Laird in Focus

Community Information Session

Tuesday, October 17, 2017

SUMMARY REPORT

Eglinton Avenue Study Area: Charrette Results

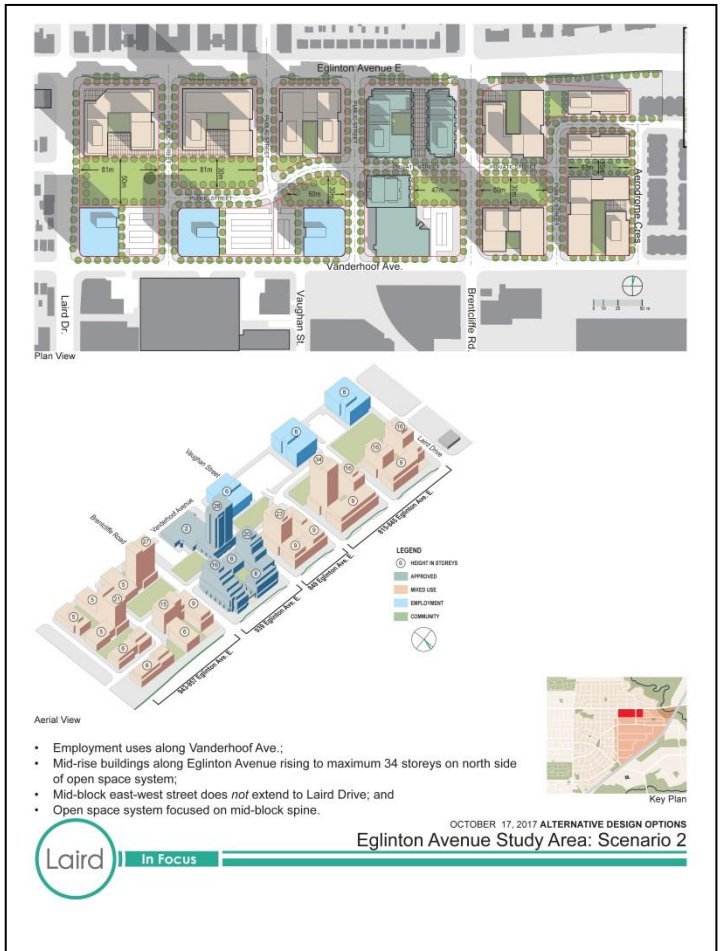
- Scenario 3 – Afternoon Session: Please don't consider this. We already have enough traffic filtering through residential Leaside

Eglinton Avenue Study Area: Scenario 2

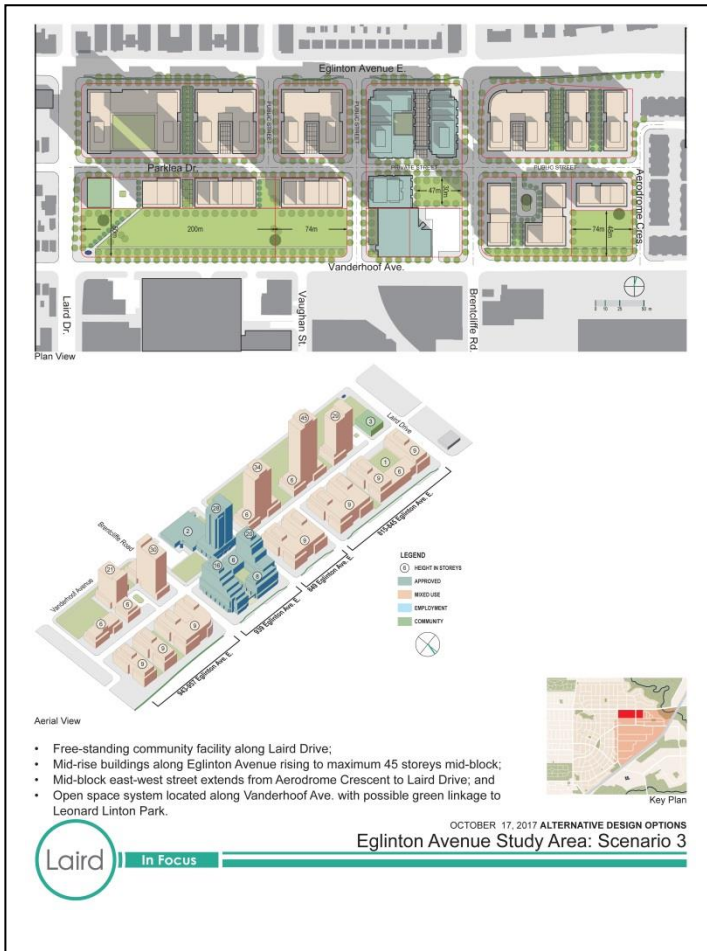
- Need retail, grocery store, LCBO, hardware store, services, doctor, and dentist
- Real mixed use at the LRT
- Way too much density
- Need affordable housing for families
- Affordable housing isn't possible
- Housing for seniors
- Playgrounds for kids
- Dog parks

Laird Drive Study Area: Parkhurst and Laird

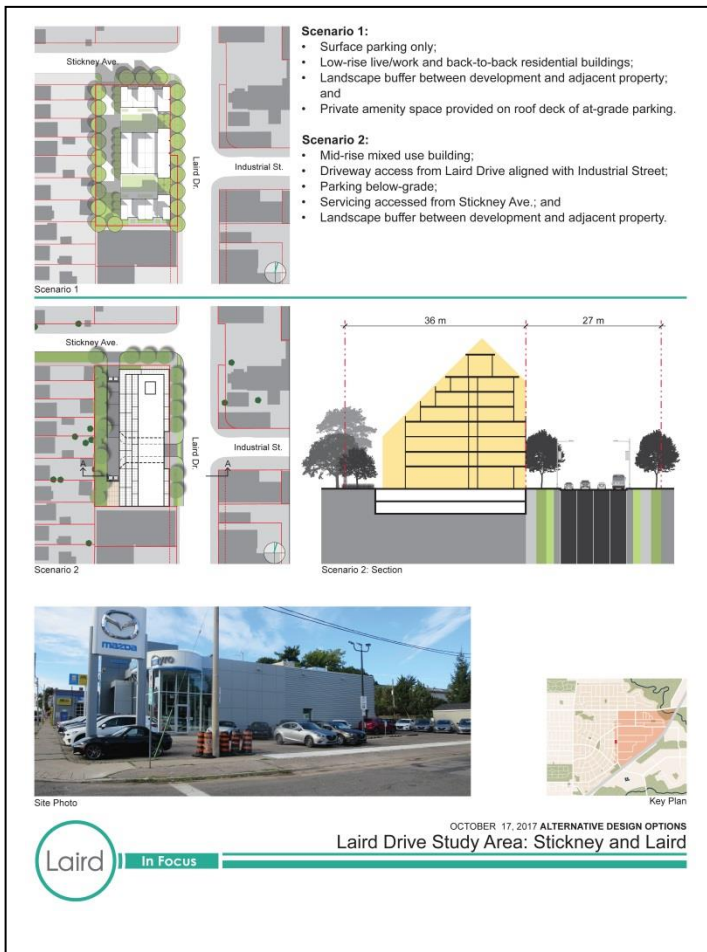
- They all look good
- Don't like Scenario 1 or 2

- Low-rise commercial building at Laird Drive and Vanderhoof Avenue are good
- Live/work units along Laird Drive and Parkhurst Boulevard are good
- Rear lane parking accessed from Parkhurst Boulevard are too close to the corner

- Don't like the mid-rise building at Laird Drive and Parkhurst Boulevard

Laird Drive Study Area: Malcolm and Laird

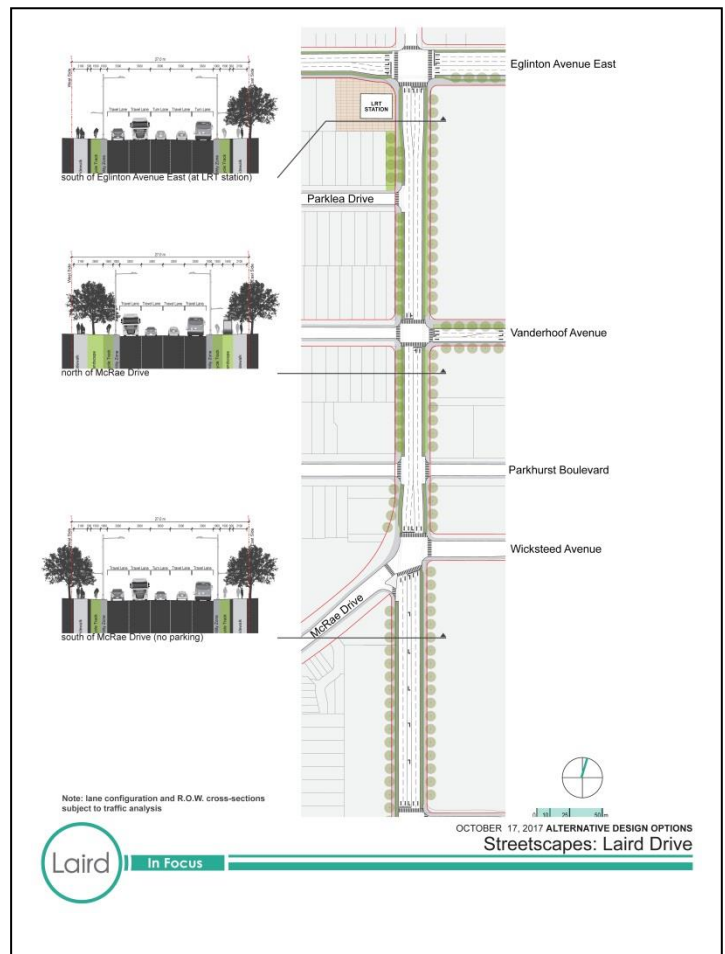
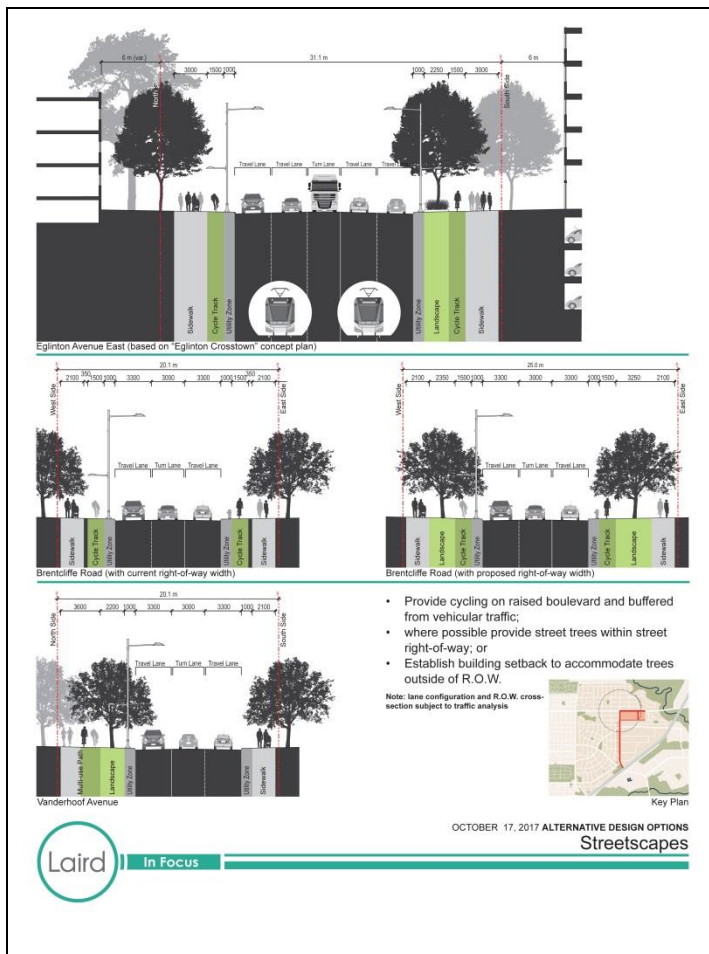
- The bump-out is useless

Streetscapes: Laird Drive

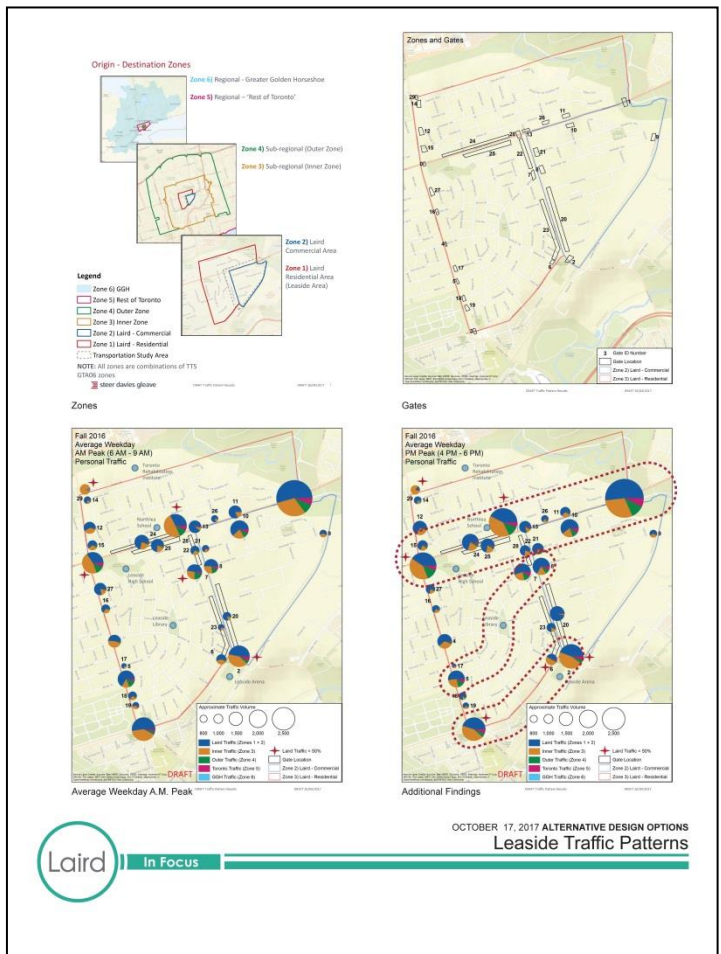
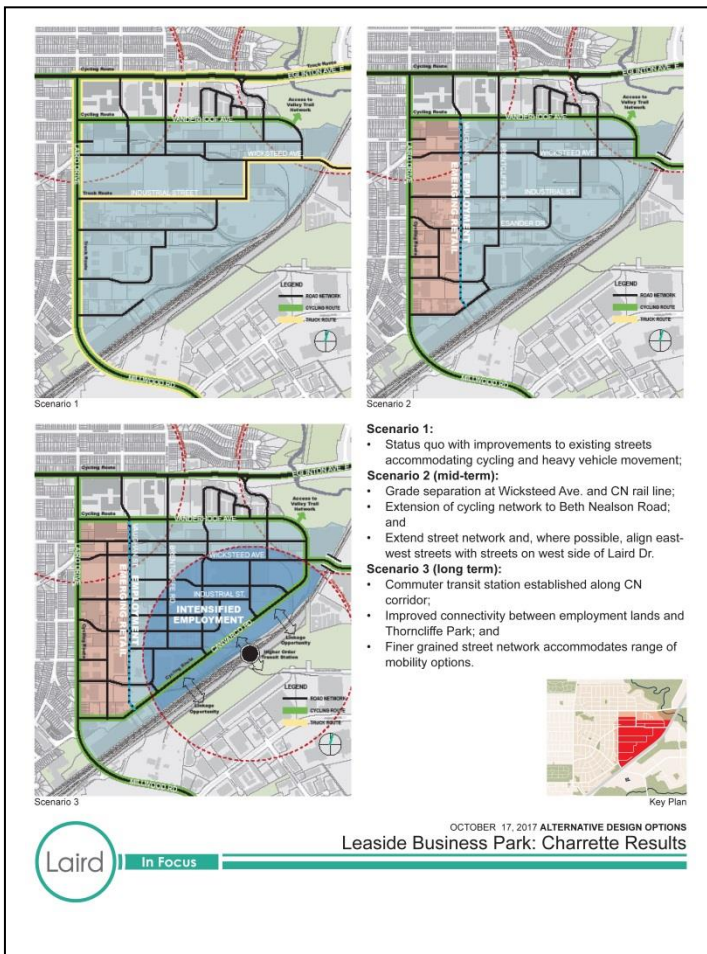
- Changes will be better for pedestrians
- No through traffic on Vanderhoof Avenue [across Laird]
- This is a big concern. Currently, traffic can't go across Laird Drive from east to west. This proposes a traffic light and having a three lane street becoming a small residential street. There is already enough traffic filtering through Leaside
- Allow through traffic, mostly 'Leasiders'

- Need a boulevard preventing traffic crossing Laird Drive from one side of Parkhurst Boulevard to the other
- Don't have through traffic on Parkhurst Boulevard

- Straighten up the Wicksteed Avenue / McRae Drive intersection
- Not having street medians is good
- Need more crosswalks
- Consider water runoff, underwater stream
